**OFFICER REPORT No. 7 Chapter 5 WQN2**

**PROPOSED VARIATION 1 OF THE  
PROPOSED CANTERBURY NATURAL RESOURCES  
REGIONAL PLAN:**

**Chapter 5 – Water Quantity – Interference effects  
between bores**

**5-258-22 Figure WQN13: Illustration showing the protected available drawdown in a well**

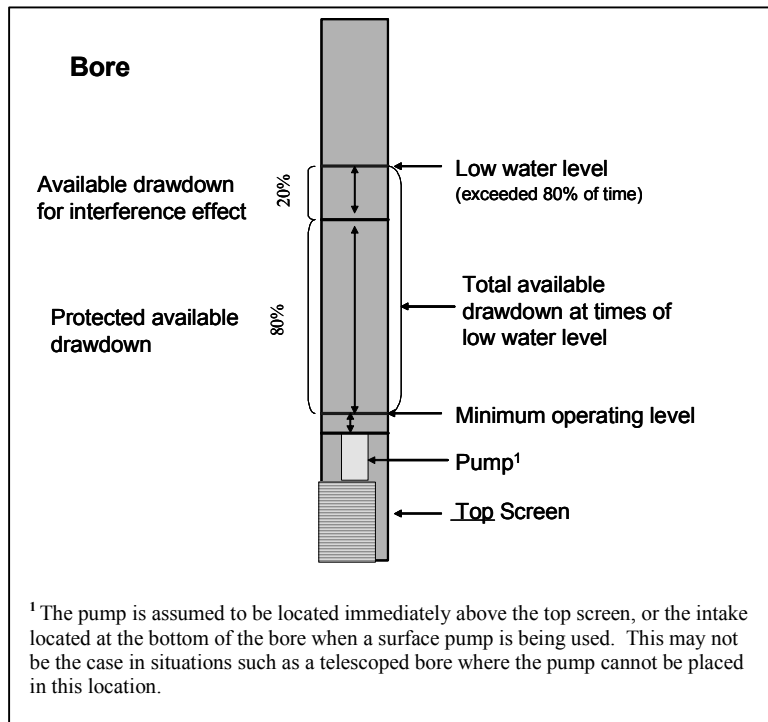
5-258-22	476.489	Christchurch City Council*	Amend Figure WQN13 to produce companion figure allowing for use of a surface mounted pump.
----------	---------	----------------------------	--------------------------------------------------------------------------------------------

**476.489:** This submission requests that Schedule WQN10 be amended to include a “companion figure” to Figure WQN13 that illustrates the protected available drawdown in a bore with a surface pump. Such a figure would look very much like Figure WQN13, but without the pump above the screen, which may or may not be present. While these differences are minor, they are also significant when assessing interference effects on shallow bores. Therefore, it is agreed that it would be helpful to amend Figure WQN13 so that it applies to bores with surface and submersible pumps. This is considered to be a better option than adding an additional figure.

Amend Schedule WQN10 at line 23 by revising Figure WQN13 as shown below:

**Figure 1 Drawdown curves for the highlighted table 1 example**

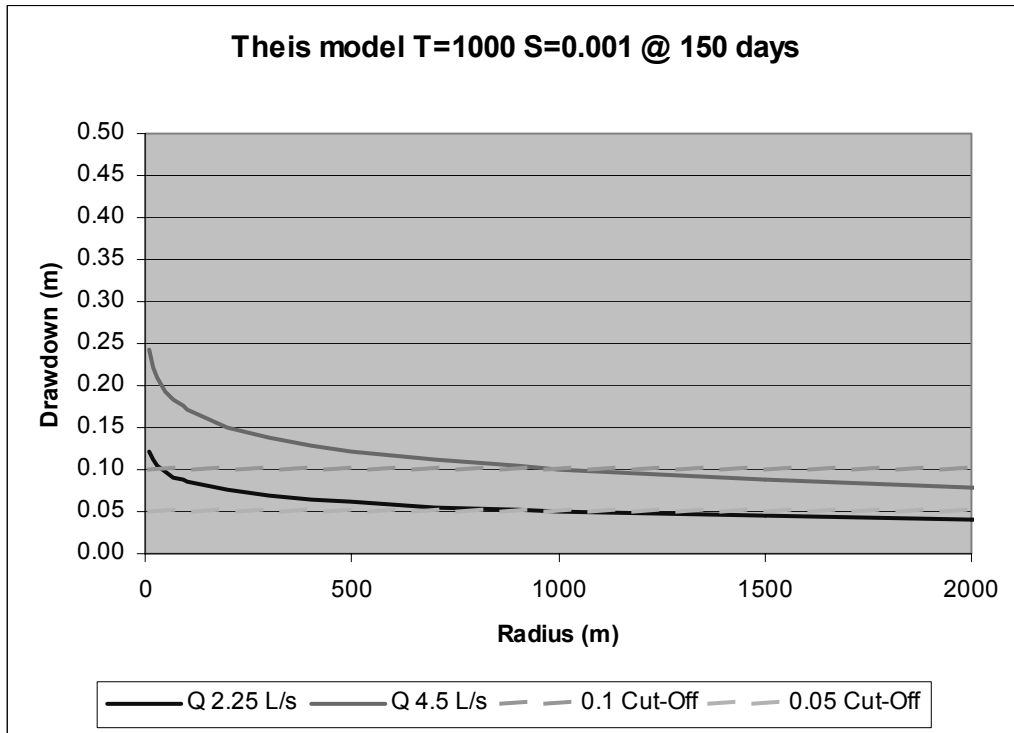
Looking at the highlighted example more closely; Figure 1 shows the drawdown curves for a take using the Theis(1935) drawdown model with a simulated 150 day abstraction, a transmissivity (T) of 1000 m<sup>2</sup>/day and a storativity (S) of 0.001.

Under the present cut-off the maximum rate of take is an average of 2.25 L/s (195 m<sup>3</sup>/day) over 150 days. Under the proposed cut-off this increases to 4.5 L/s (389 m<sup>3</sup>/day). Additionally under the present cut-off a take of 4.5 L/s would have exceeded 0.05 out to 5 km which is an overly conservative distance to consider for a take of this size.

An adjustment of this cut-off to 0.10 m is therefore proposed to ease the WQN10 criteria. The effect of changing the cut-off from the present level of 0.05 m is that some small takes will not have to consider the effects of all bores within 2km. This change will ease the WQN10 criteria for small takes whilst retaining a level precaution for larger takes.

0.1 m represents the minimum change that can be easily observed, and attributed to interference. For example an air pressure variation of 1 kPa will result in a water level change of approximately 0.1 m in a barometrically efficient aquifer (as a comparison 1 hPa is the expected diurnal change in New Zealand)

**Figure WQN7: Illustration of adequate and inadequate penetration of the aquifer and of bore interference**

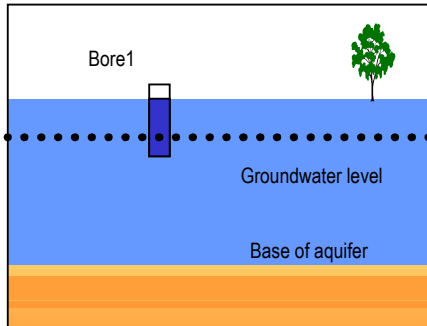
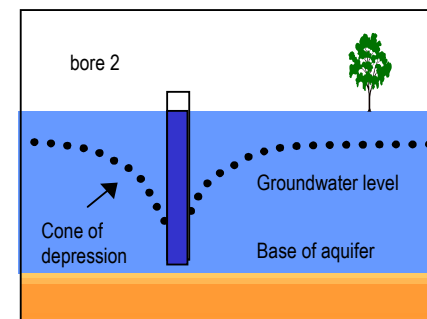
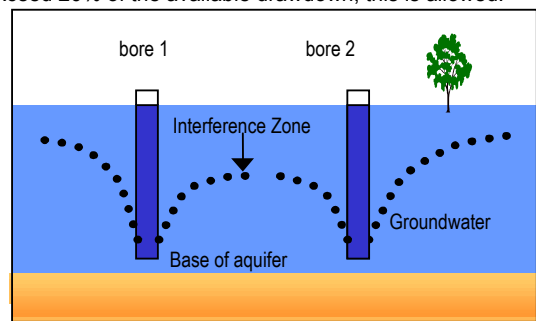
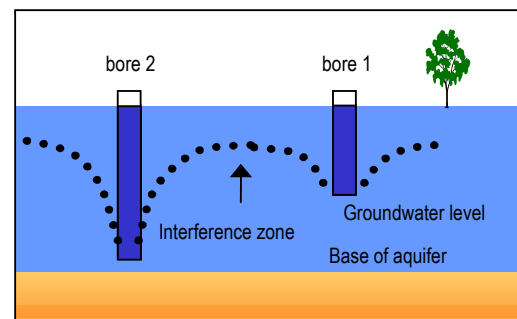
**5-118-1 Figure WQN7: Illustration of adequate and inadequate penetration of the aquifer and of bore interface**

**476.482:** Submission 476.482 requests that Figure WQN7 be retained as worded, although no reason is given. As this figure is considered to provide a useful illustration of adequate and inadequate penetration of an aquifer as per Policy WQN20(2)(a) and (b), and of well interference effects as per Policy WQN20(1) and (2)(c) to (e), the submission is accepted. No amendment is required.

**560.4:** This submission requests that the reference to Figure WQN12 in the schedule on page 5-258 at line 21 be amended to Figure WQN13. This submission is accepted so that this error can be corrected, and an amendment is required. A consequential amendment is also required in Figure WQN7, which also mistakenly refers to Figure WQN12.

A consequential amendment is required to Figure WQN7 on page 5-118 at lines 11/12 after Scenario 2 as follows:

“...drawdown (see Figure WQN123).
